APPROVAL OF THE REVISED ADDENDUM TO THE REVISED WORK PLAN FOR EAST RAVINE GROUNDWATER INVESTIGATION, AND FINAL REVISED IMPLEMENTATION PLAN FOR REPAIR OF MONITORING WELLS MW-38S AND MW-38D AND OLD WELL/ PIPE RECONNAISSANCE AT PACIFIC GAS AND ELECTRIC COMPANY (PG&E), TOPOCK COMPRESSOR STATION, NEEDLES, CALIFORNIA (EPA ID NO. CAT080011729)

MEMORANDUM

SUBJECT: FORMER WELL / PIPE IN BAT CAVE WASH
PACIFIC GAS AND ELECTRIC COMPANY
TOPOCK COMPRESSOR STATION
NEEDLES, CALIFORNIA (EPA ID NO. CAT080011729)

Figure 1. January 26, 2011. Northeast view from Bat Cave Wash showing general area where Mr. De Lay recalled welding a lid onto the top of an old well.

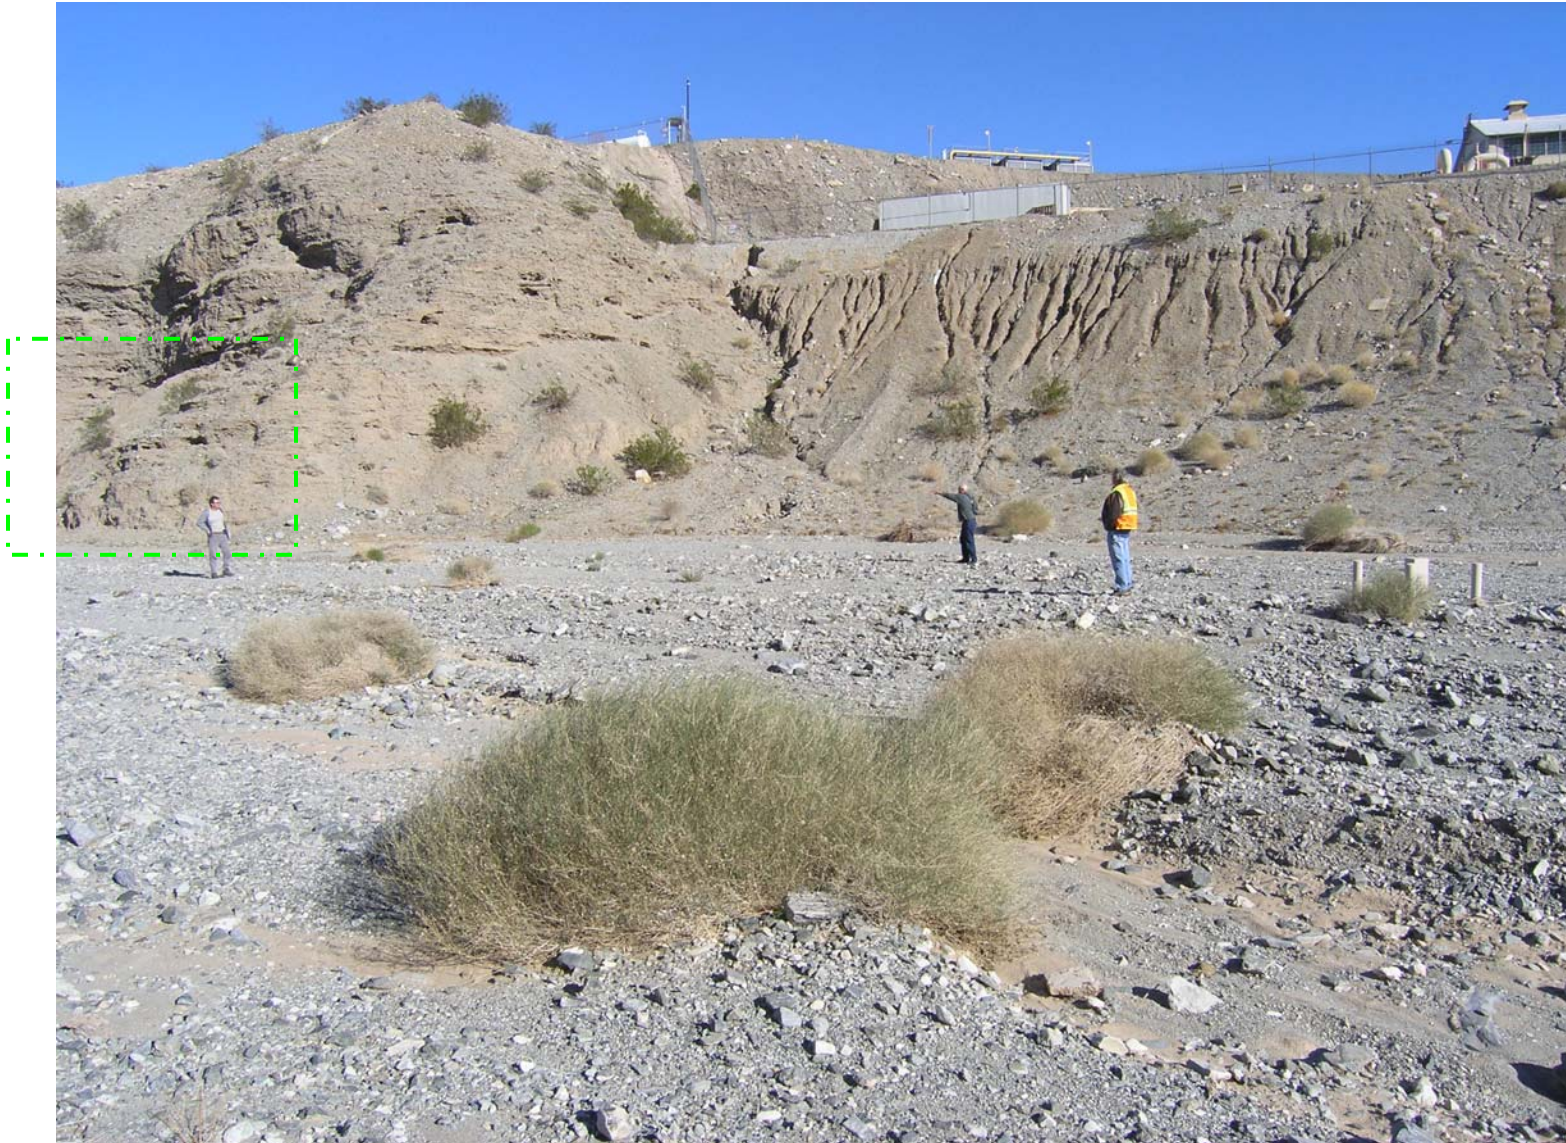
According to the *Revised Final RCRA Facility Investigation Report, Volume 1, Site Background and History, PG&E Topock Compressor Station*, dated August 2007 and prepared by CH2MHill, a plant employee welded a cap onto an approximately 12-inch diameter vertical pipe located in Bat Cave Wash. The pipe looked like a regular well casing and only extended a small amount above the ground. Department of Toxic Substances Control (DTSC) staff discussed the occurrence of the old well / pipe in Bat Cave Wash with Pacific Gas and Electric (PG&E) representative Mr. Curt Russell and former PG&E Topock Compressor Station employee Mr. Bill De Lay on January 26, 2011. Mr. De Lay specified where he recalled welding the well shut sometime in the 1980s. The area he identified is pictured in Figure 1 as well as on Figure 6. He indicated that the approximate location of the well was bounded by existing groundwater monitoring well MW-10 (located to the right in Figure 1) and by the person pictured to the far-left in Figure 1 and that the well was located closer towards the middle of the wash.

Based on Mr. Delay's account of the location of the old well, DTSC staff reviewed historic photographs of the PG&E Topock Compressor Station that were included in PG&E's August 22, 2007 letter/DVD disk titled *Photos of the Topock Compressor Station and vicinity*. A few historic photographs were found of a temporary water supply well that was operational in March 1951 (Figures 2, 4 and 5). Examination of the background in Figure 2 illustrates a distinctive rock outcrop that can be viewed in current photographs of Bat Cave Wash (Figures 1 and 3). This rock outcrop is highlighted in green in the 1951 Figure 2 photograph and the area has also been highlighted in current photos (Figures 1 and 3).

Based on this information, DTSC believes that the old well / pipe described in the 2007 RFI Volume 1 Report and by Mr. De Lay may be the old 1951 temporary water supply well shown in Figures 2, 4 and 5. DTSC recommends that this information be considered by PG&E to assist in locating the old well as planned in PG&E's February 11, 2011 Technical Memorandum entitled *Final Revised Implementation Plan for Repair of Monitoring Wells MW-38S and MW-38D and Old Well/Pipe Reconnaissance*.
